Draft Technical Memorandum

Subject: Technical Comments on Farallon Letter Regarding Additional Deep Monitoring Well – EFR HQ IVES Site, Issaquah, WA

CDM Smith has reviewed the April 8, 2026 Farallon Consulting letter that responds to the Washington State Department of Ecology's request for installation of an additional deep monitoring well in the identified data gap area between City of Issaquah and District production wells. This letter was provided to the District by Ecology on June 4, 2026.

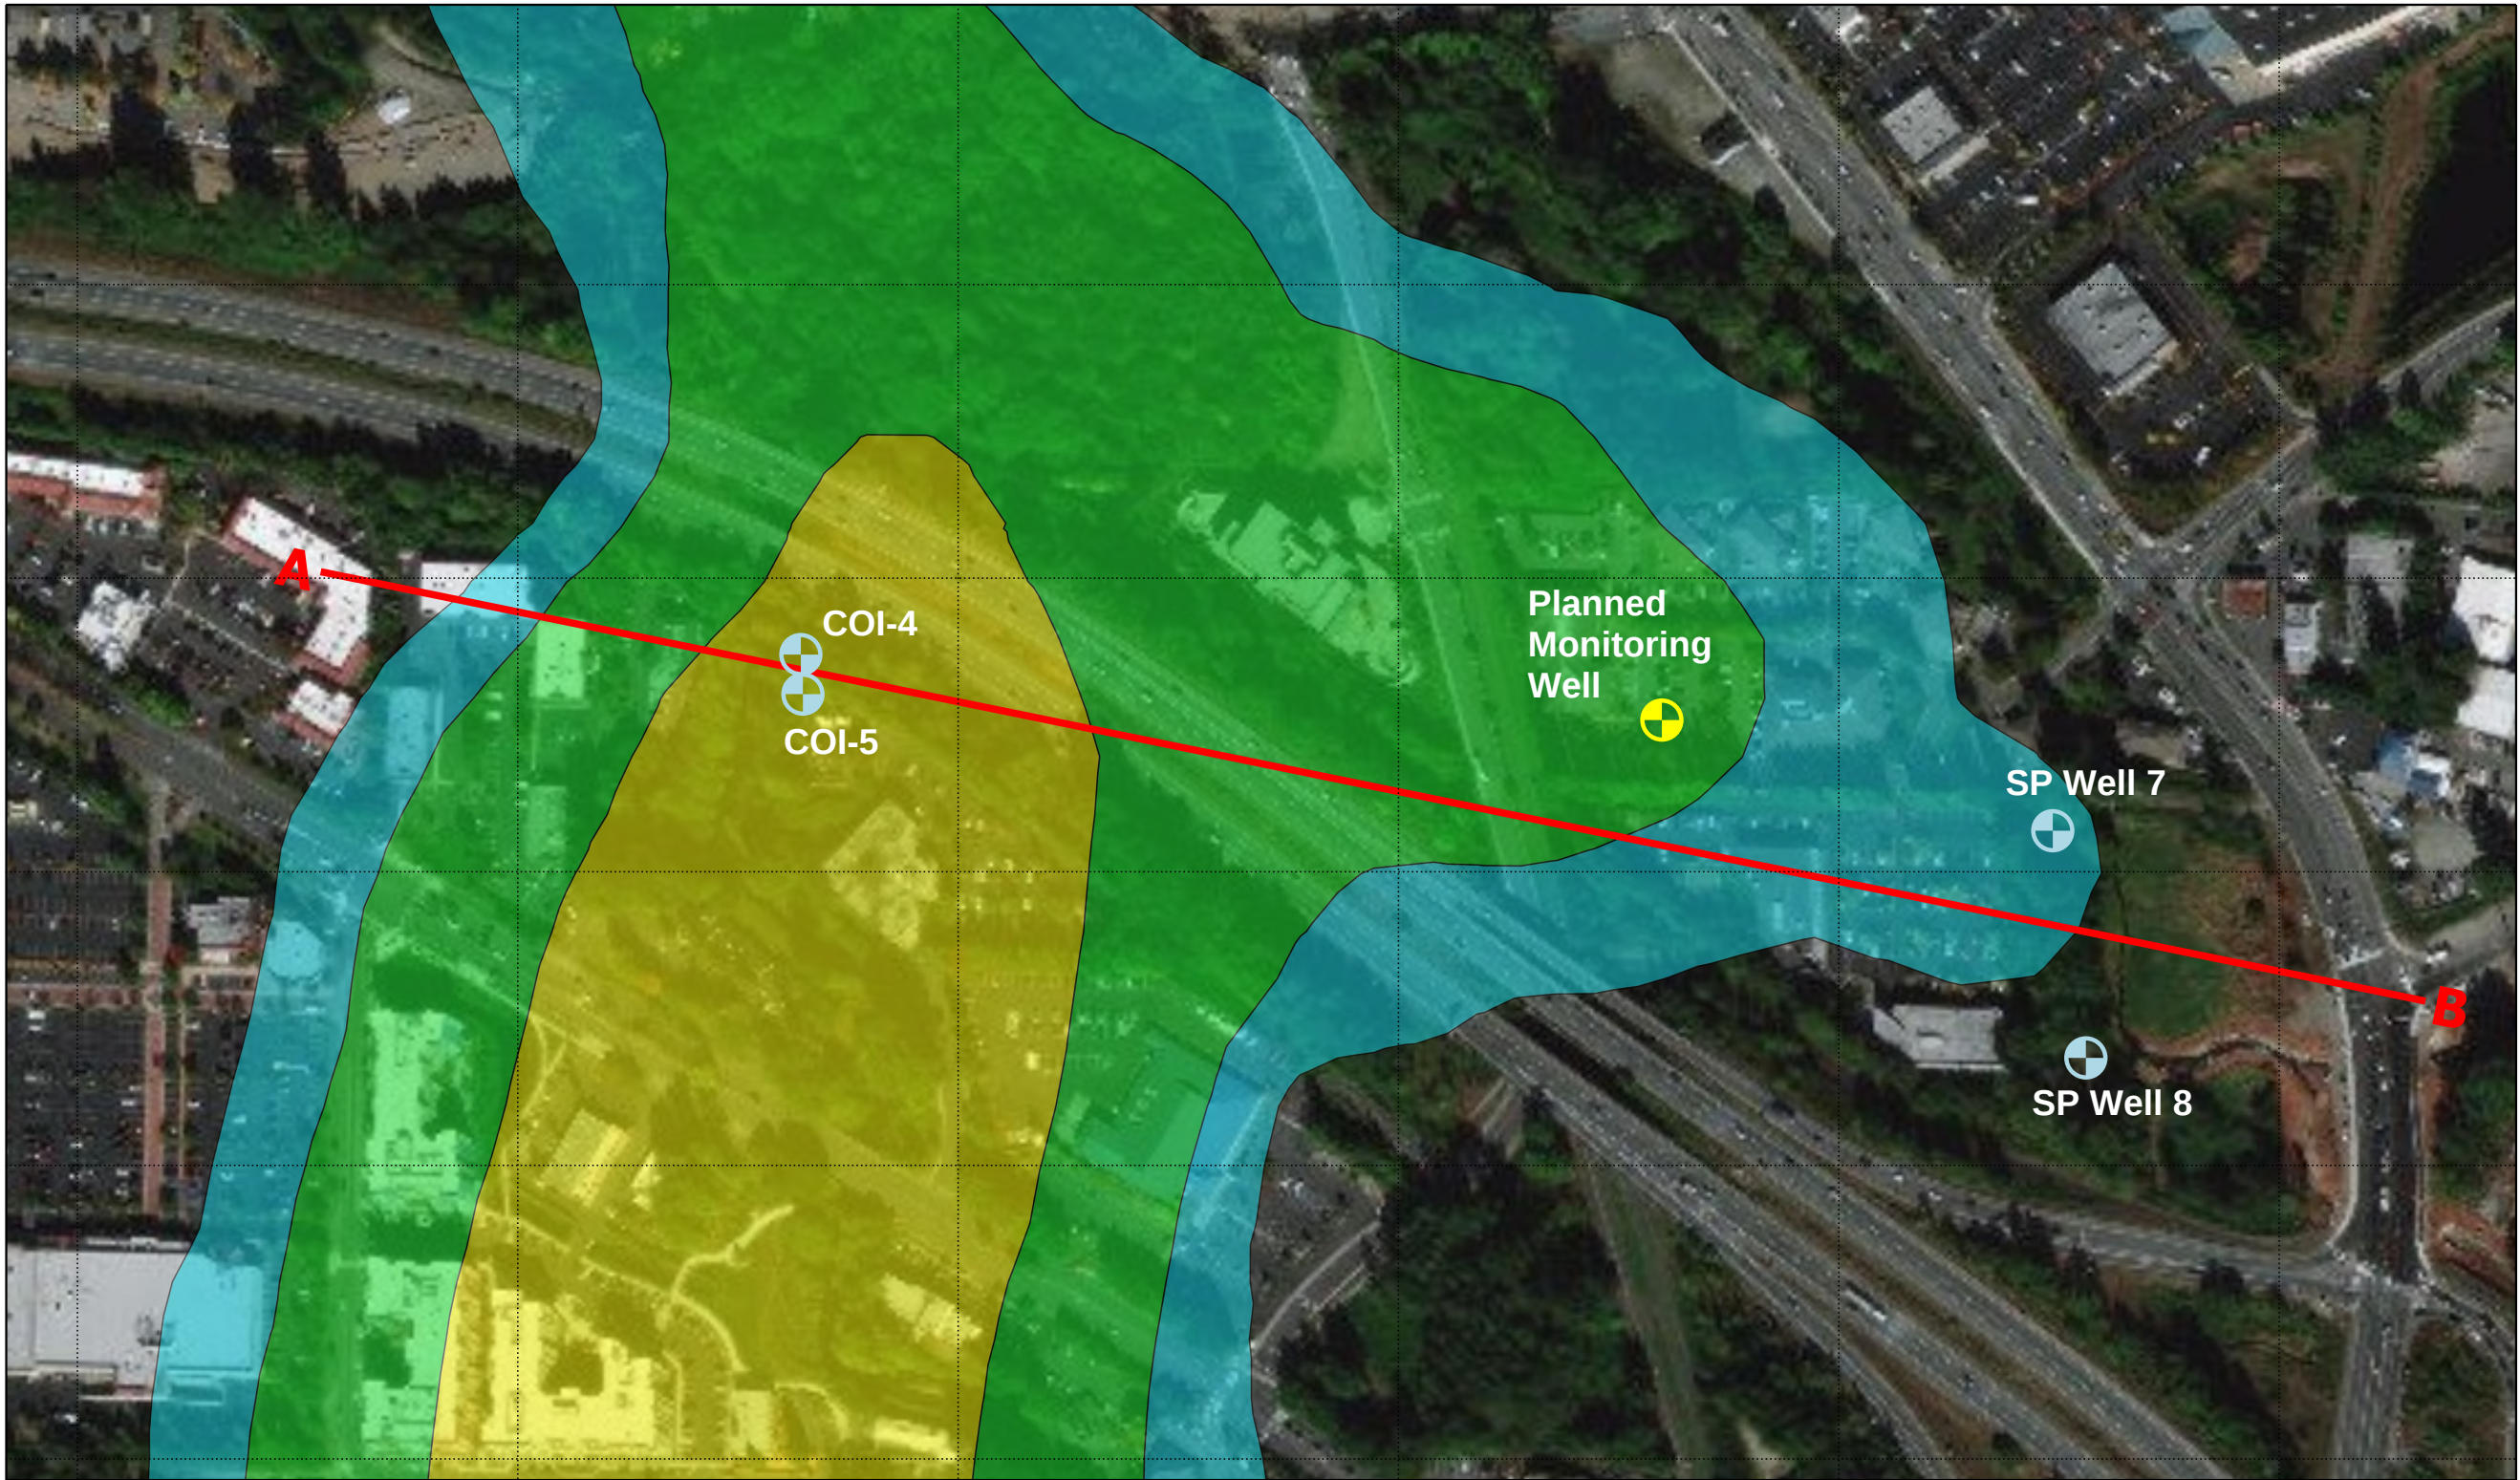
As identified in the District's Data Gap Memorandum (CDM Smith, 2025) failure to install a monitoring well in the identified area will likely result in:

- Incomplete understanding of plume extent and magnitude
- Inability to evaluate exposure pathways
- Incomplete information for evaluating cleanup alternatives
- Delays in feasibility study (FS) development, remedy selection, and implementation of remedial actions

For the reasons outlined above, exploration in the identified data gap area is a necessary next step for the MTCA RI. This exploration would be conducted via a temporary borehole to approximately 250 feet that would grab groundwater samples at 3 to 5 discrete depth intervals in the upper and intermediate water bearing zones as well as the intervening silt unit between the water bearing zones. After sampling results from the temporary boring are reported and validated, a permanent monitoring well at a depth where the greatest concentration of PFAS plume contamination is discovered will be installed for future monitoring. This next step is necessary to fulfill MTCA RI requirements and to ensure a complete and defensible understanding of PFAS plume extent before proceeding with evaluation of cleanup alternatives.

We respectfully request that Ecology proceed with the additional data collection described in its March 26, 2026 letter to the District and require monitoring well installation needed to adequately characterize the site. A proposed plan view and cross section showing the District's recommended location and sampling proposal are attached.
